Local Review LRB Ref 153

Planning Application Reference 16/0241/PPP Erect 4 dwellinghouses on Site to Rear of Heatherlea, Main Street, Tomintoul

Response from Transportation, Moray Council

TMC02 – SITE PHOTOGRAPHS

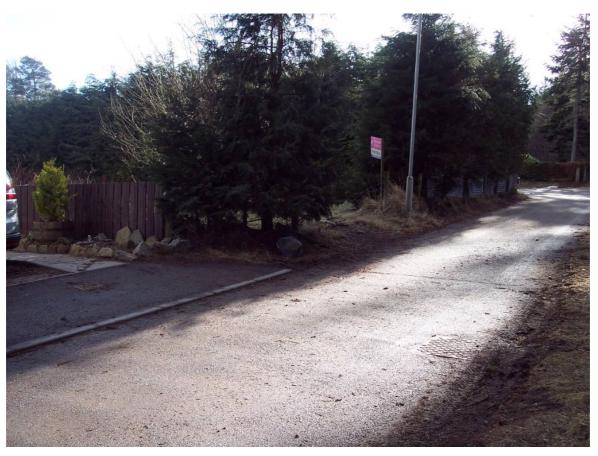
- 4. The site is access via the U136H Tomnabat Lane which is narrow lane serving four existing properties. The road frontage of the site is some 20 metres long. There is no footway provision along the frontage of the site. A street lighting column is sited some 6 metres from the northern boundary of the site. Photographs from Transportation's site visit are attached (TMC02).
